Revision of Manuscript Number: IEEE-TPWRS-01391-2021, version 1 March 8, 2022

Journal: IEEE Transactions on Power Systems

Author: Abhishek Halder, Kenneth F. Caluya, Pegah Ojaghi, Xinbo Geng

Response to decision:

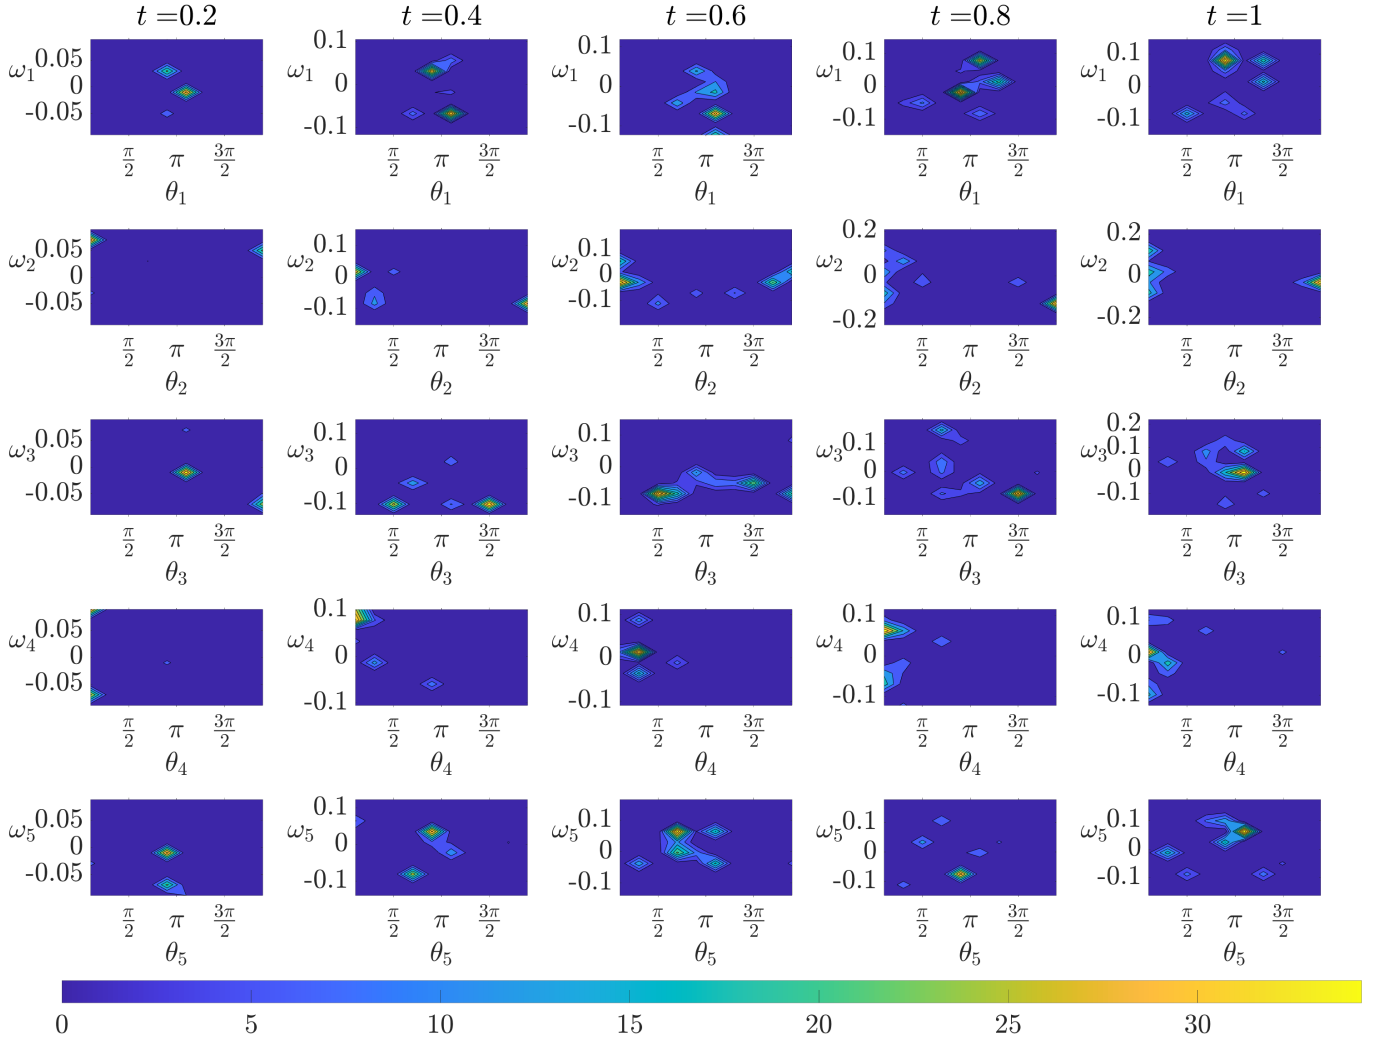
Figures 5 and 6 are unreadable.

Response: Thanks for this comment. In the previous version, the strict 10 page limit enforced small figure sizes. In the revised manuscript, Figures 5 and 6 are made larger. Also, the Fig. 6 in the revised manuscript shows the transient (θ_i, ω_i) bivariate marginals for all the five generators in Case II; the previous version showed the same only for the generator 4 (bus 6). We believe these changes have improved clarity.

Regarding the style of plots, we had considered plotting the bivariate marginals as planar contour plots (as in Fig. 1 in this rebuttal document) but decided against it because of the following two reasons.

First, in our opinion, this kind of plot is scientifically misleading as they hide the fact that these bivariate marginal PDFs are not really supported on the plane, or the subsets thereof, but instead have cylindrical supports. Our message that the proposed method explicitly accounts this manifold geometry in the computation, would be missed had we chosen to make the plots the other way.

Second, the planar contour marginal plots require additional mental efforts from the readers to correctly parse the statistical information conveyed. For instance, consider the fourth column, second row subplot in Fig. 1 in this rebuttal document. It is upon the reader to parse that the two high probability regions on the left and right of that subplot are actually referring to the same angular high probability region around $\theta_2 = 0$ rad, thanks to the periodic boundary condition on the angular variable. We thus prefer to make plots that depict the variables as they are.
